**CITY OF KIRKLAND**  
**Planning and Building Department**  
123 Fifth Avenue, Kirkland, WA 98033  
425.587.3600 ~ [www.kirklandwa.gov](http://www.kirklandwa.gov)

**To:** Design Review Board  
**From:** Aoife Blake, Associate Planner  
**Date:** September 6, 2022  
**File No.:** DRV22-00466  
**Subject:** **SWYFT APARTMENTS  
DESIGN RESPONSE CONFERENCE**

# SWYFT APARTMENTS

DESIGN RESPONSE CONFERENCE

## DRC // SCALE REFINEMENTS

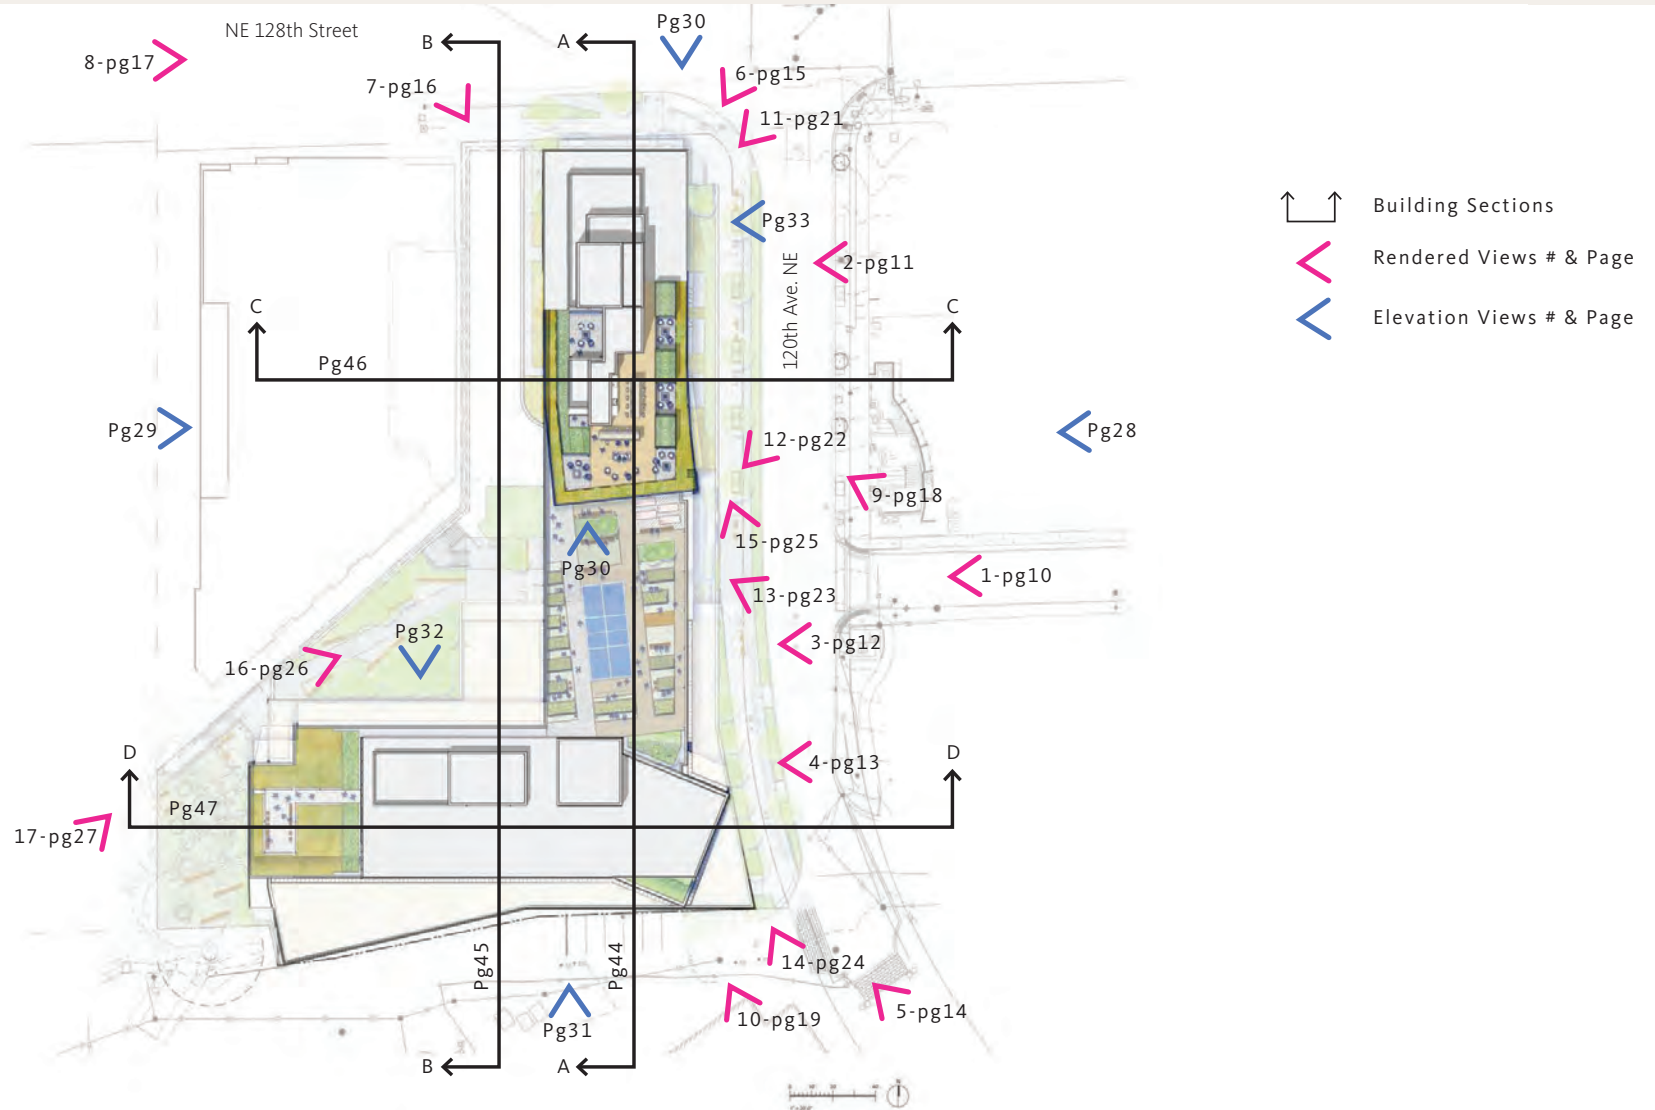
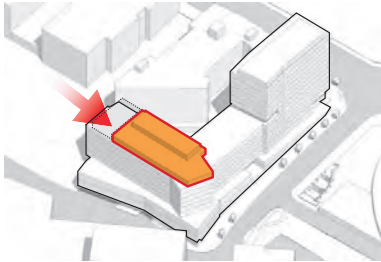
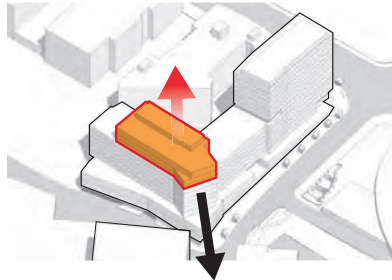
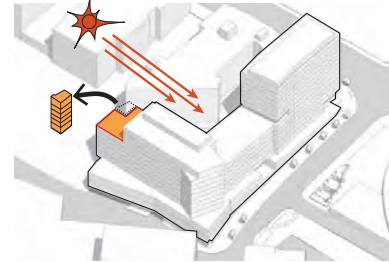
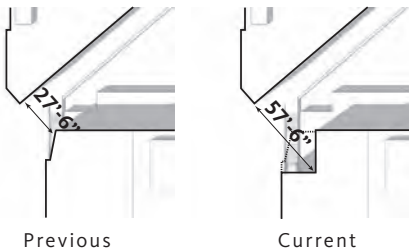
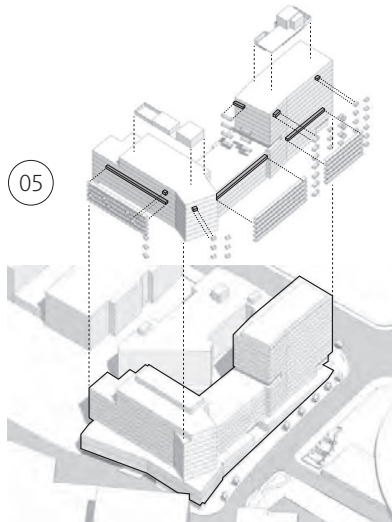
DRB noted some issues around the suitability of the mass on the north side and around how to mitigate the mass of the building. They suggested more refinement is needed as the project design develops to break up the mass of the building. Encouragement to look at a "two-tower" massing concept for complimentary scale to adjoining neighborhood. The applicant was encouraged to explore design approaches in the SW corner of the building, suggesting narrower and greater height.

Request to further refine the South building to address light and privacy to the Jade and courtyard. DRB expressed concern in terms of light and privacy in relationship to the Jade wanted further exploration.

The design team has incorporated a "two-tower" scheme by making refinements to the southern mass through several design changes:

- 01 The upper levels were made more narrow, locking the volume into the SW corner and breaking up the upper level massing.
- 02 The tower was extruded upward by two levels to better compliment the adjoining neighborhood and provide a more fluid transition in height between the existing building on the South and the two proposed stepped tower masses.
- 03 Removed podium mass to increase distance at adjacent building,
- 04 Increased level of privacy and increasing solar penetration
- 05 Facade articulation applied to further break down buildings masses into distinct elements
- 06 Refinement of pedestrian frontage incorporating detail and art
